RICHARD SUMMERS INC.
ATTORNEYS

RE: COMMENT ON DRAFT ENVIRONMENTAL IMPACT ASSESSMENT (EIA) REPORT FOR THE ALBANY WIND ENERGY FACILITY (DEA REFERENCE NUMBER: 14/12/16/3/3/2/1131)

Figure 1: Visual simulations of potential impact of navigation lights at night seen from the Kwandwe Private Game Reserve, which indicate a worst case scenario, as the lights would need to be determined by the CAA.

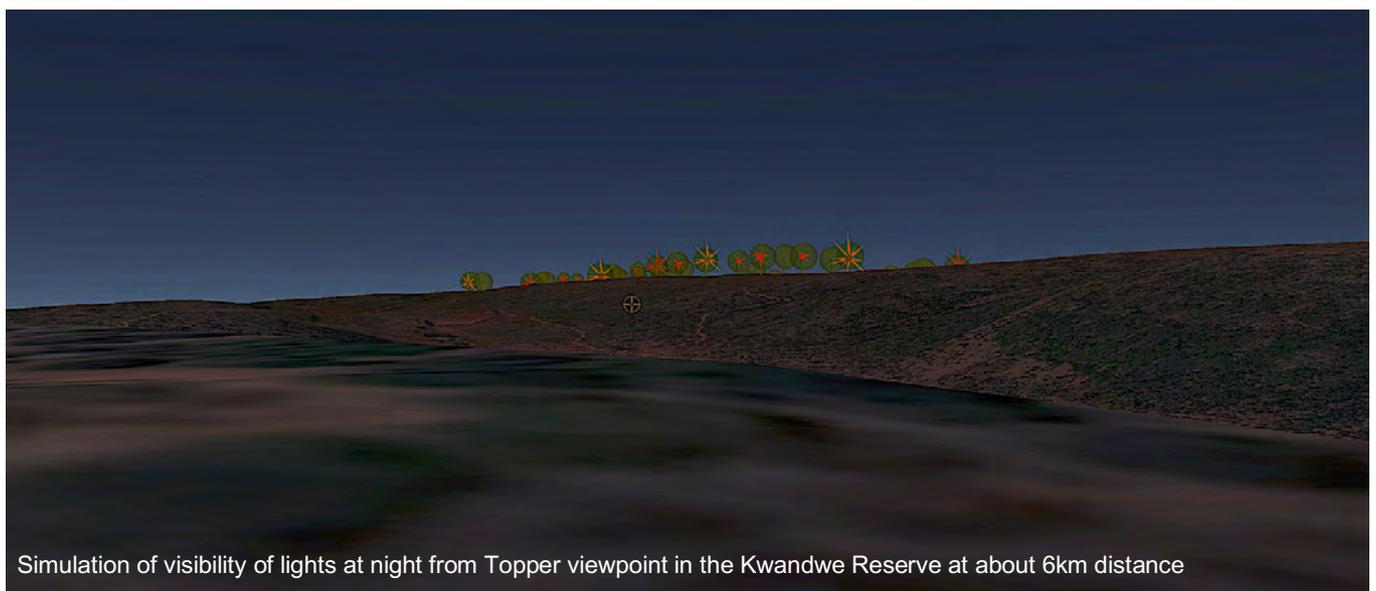
The Reviewers are in agreement with the impact significance rating for wind turbines (Operational Phase), which is stated as being HIGH both before and after mitigation. The Reviewers are not in agreement with the LOW significance rating for the powerline and

switching / substations located adjacent to the N2 National Road, because of the visual intrusiveness at close range to a major national route by these industrial-type facilities, particularly as no visual buffers or screening mitigations have been provided. The Reviewers question the MODERATE rating for lights at night, given that the red lights are more visible at a distance than during the day, particularly in a wilderness setting. (See Figure 1 below).
